SAN FRANCISCO PLANNING DEPARTMENT

Discretionary Review Abbreviated Analysis

Date: October 17th, 2013
Case No.: 2013.0271D
Project Address: 10 De Soto Street
Permit Application: 2013.02.26.0954
Zoning: RH-1(D) [Residential, House, One-Family, Detached] Zoning District
40-X Height and Bulk District
Block/Lot: 6930/013
Project Sponsor: Andy Forrest
1539 Taraval Street, Suite 203
San Francisco, CA 94116
Staff Contact: Tom Wang – (415) 588-6335
thomas.wang@sfgov.org
Recommendation: **Do not take DR and approve as proposed**

RE: Horizontal Expansion at 10 De Soto Street Violates Residential Design Guidelines Case No: 2013.0271D

Entry Way – Proposed Project

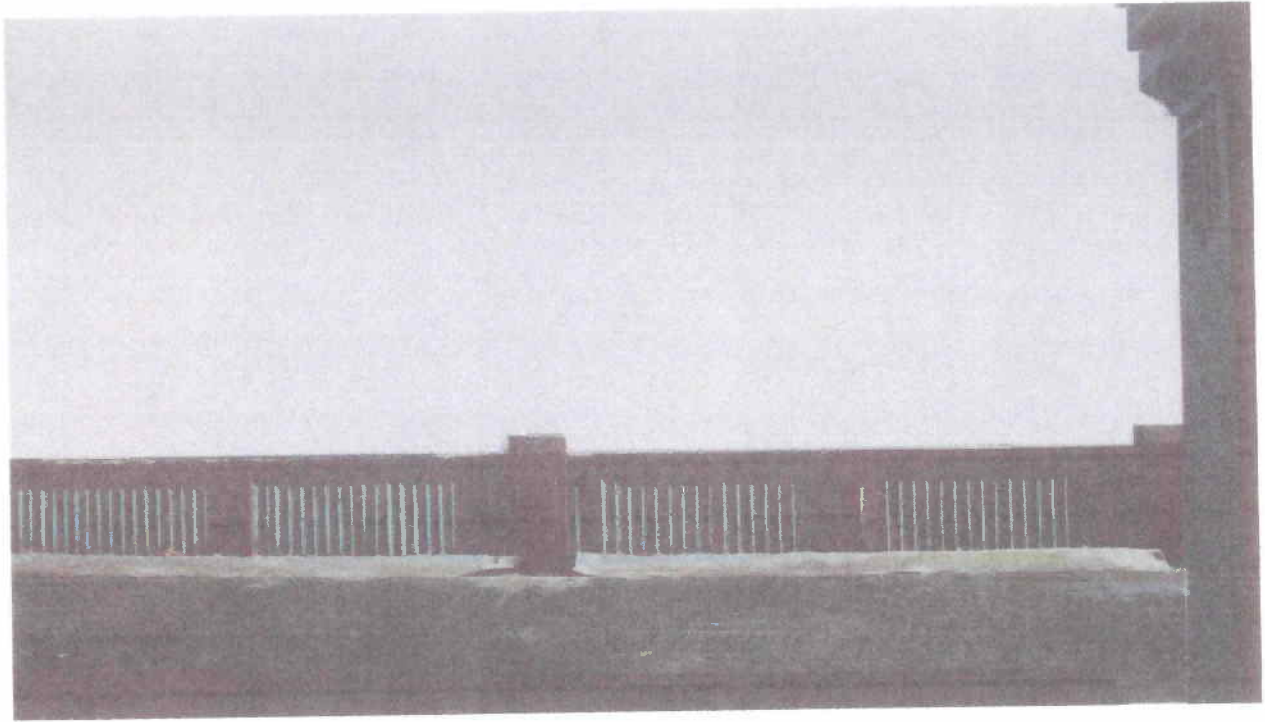
B. The expanse of the addition prevents adequate light and openness on the south side of our home.

Views with Project Proposal

Modified pictures showing how the scene would change if the original proposal was build. Grey is the color of the current house.

West Dining Room Window – Proposed Project

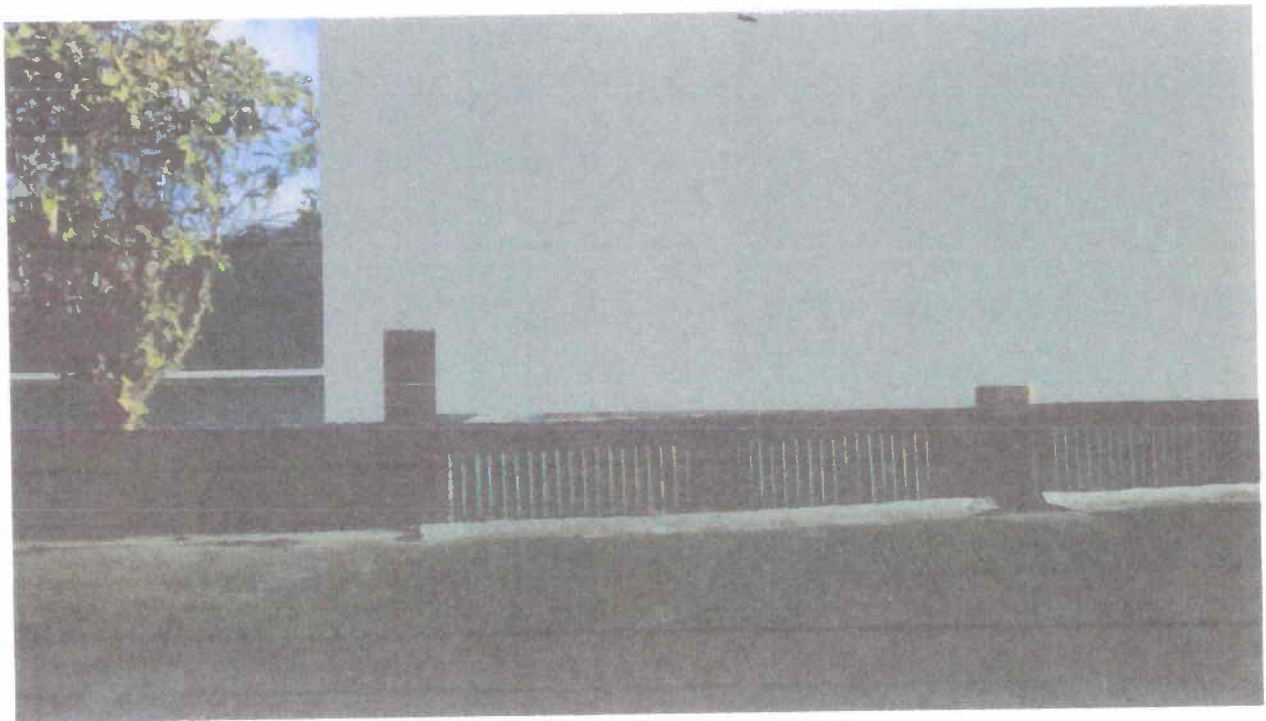
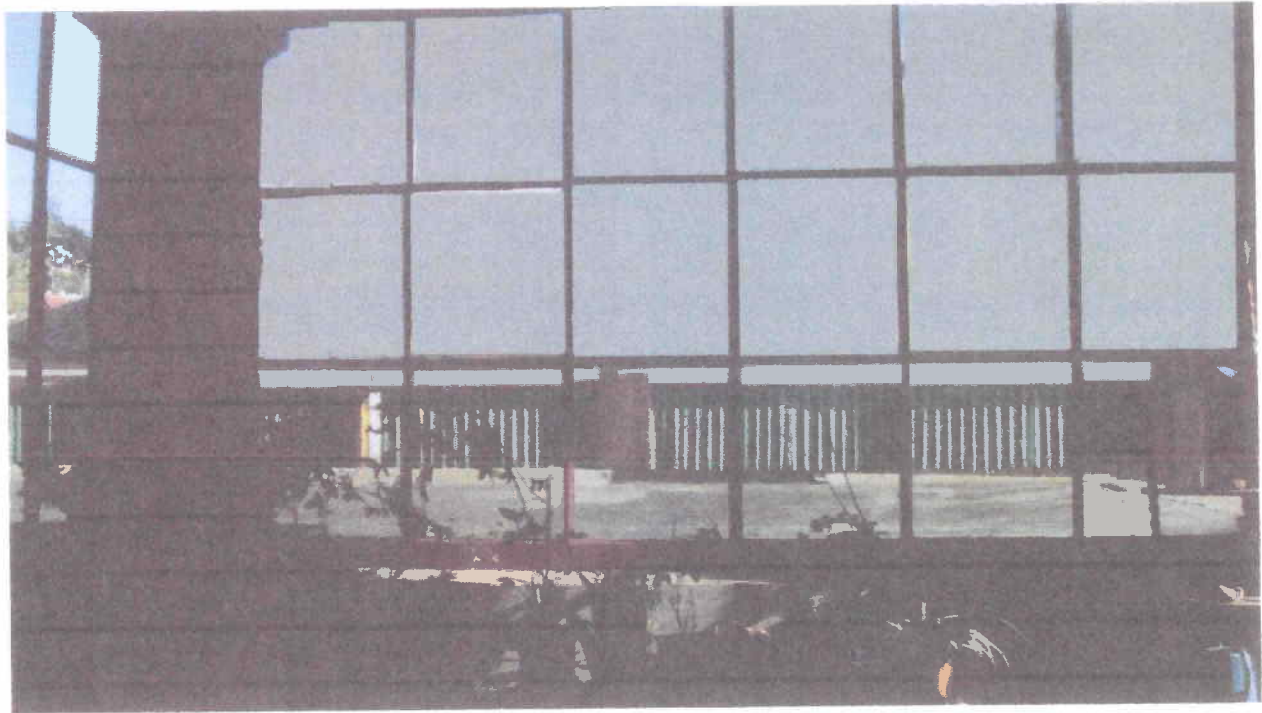
1. The view to the south shown from a dining window will be replaced by a view of a wall. The current view from our dining room windows is:

If the proposed plan is developed the view will look like this:

Additionally, the photo-shop depictions of the blank wall of the addition is misleading. It lacks the structure's architectural detailing, does not account for ambient & reflected light and is presented as a void in the view.

Entry Way - Deck Proposal – Deck changes mostly hidden by post

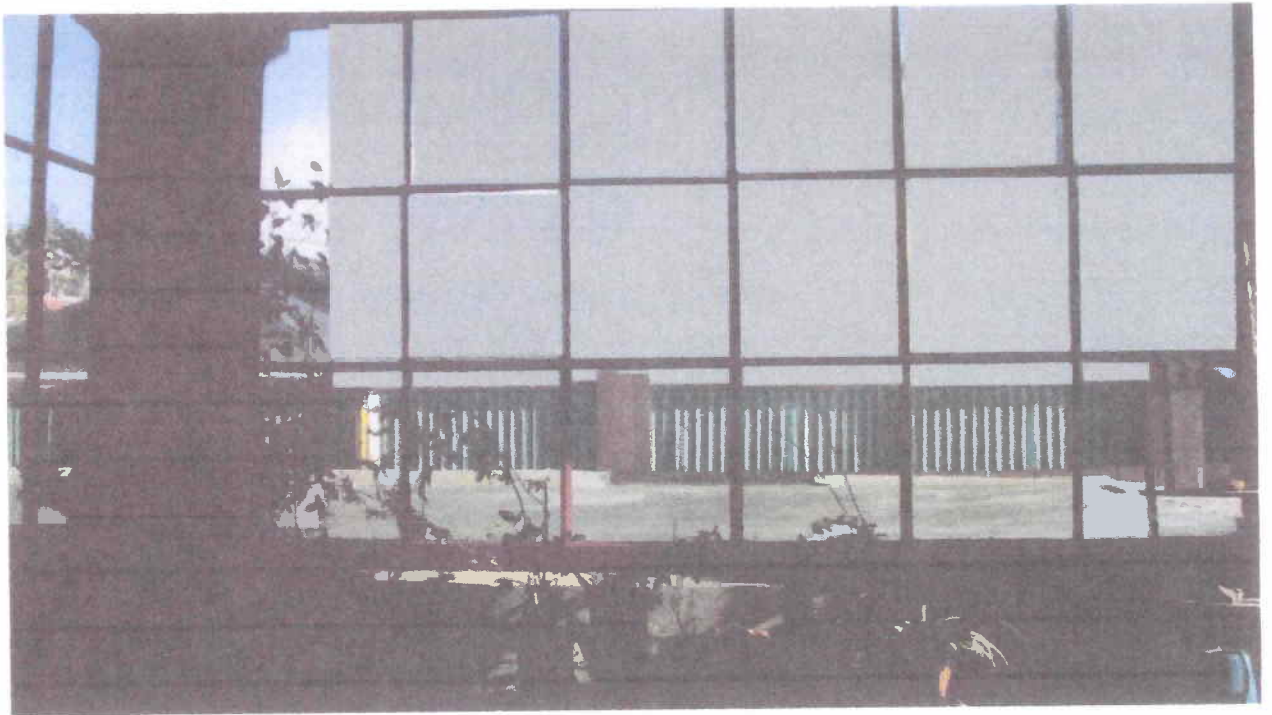
- Replace the last 8' 7" of the upper floor with an open deck. This does not change the major problems of the initial proposal – it blocks almost as much light as the original proposal and does not address our other concerns. In addition, it raises an issue of privacy since the deck to be facing one of our upstairs bedrooms. As a side note, five two story houses on this block of De Soto were built with second floor decks. All of the decks were later enclosed. We had one; it was too cold and windy to use.

Views with Alternative with deck as last 8'7" of second floor

2. We have offered to remove a 19'-3" wide by 8'6" rear room on the 2nd floor along with installing a flat roof instead of a hip roof. When we received notice the next door neighbor had concerns with the proposed project we immediately contacted them to set up a meeting. We were surprised the DR Requestor stated they have not received the pre-application notice. Other neighbors along with five members of the Ingleside Terrace Homeowners Assn. were in attendance as a result of the pre-appl. Notice. In fact, it was stated in a passing comment during the pre-appl. meeting how surprised it was the neighbor to the North was not interested in the project. In conversations with the adjacent neighbors to the South, the couple who have lived there for many years did not have an objection to the project. They requested security gate modifications which have been completed. The above offered modifications were presented to the DR Requestors at the 1st meeting after the 311 poster was installed on the property.
